Work Order ID 114764

D4634-5 AFT, CENTER CEILING PANEL

DESIGN	RF	**DART AEROSPACE LTD** HAWKESBURY, ONTARIO, CANADA
DRAWN	RF	
CHECKED		DRAWING NO. D4634 REV. F
MFG. APPR.		SHEET 14 OF 17
APPROVED		TITLE CENTER CEILING PANELS SCALE NTS
DE APPR.		
DATE	14.02.03

From: Roberto Fuentes
Sent: Wednesday, April 23, 2014 5:06 PM
To: Eric Downing
Cc: Patrick Smith; Nigel Forbes; Mike Petsche; Harvey Siemens
Subject: RE: D4634-5

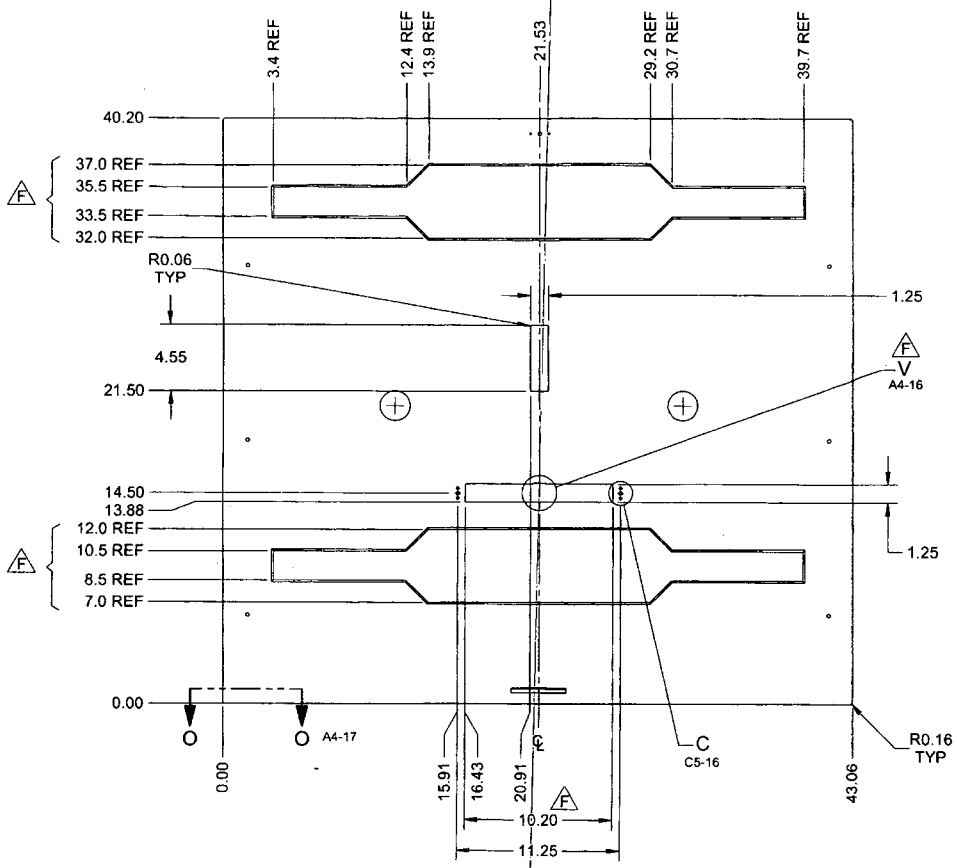
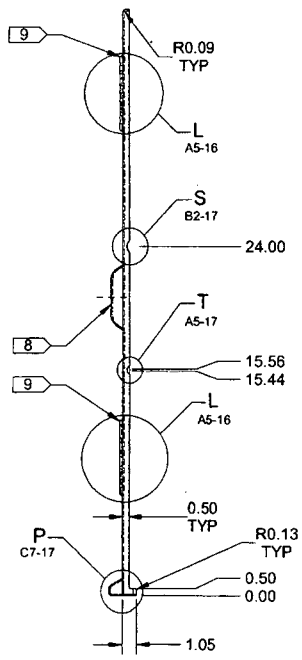
During an inspection I have found that on D4634-5 aft center panel the center cut out that's located @21.50" +/- 0.030" is measuring 21.375". I have checked the cutting & drilling template myself and have found that it is measuring wrong.

Is this deviation acceptable? And please check the DFX file for the template Roberto to ensure that it is correct.

Yes this deviation is acceptable. I don't think we are going to update this drawing in near future just for this, my recommendation if easy for Daryl to modify his template, if not use this e-mail for accept this deviation.
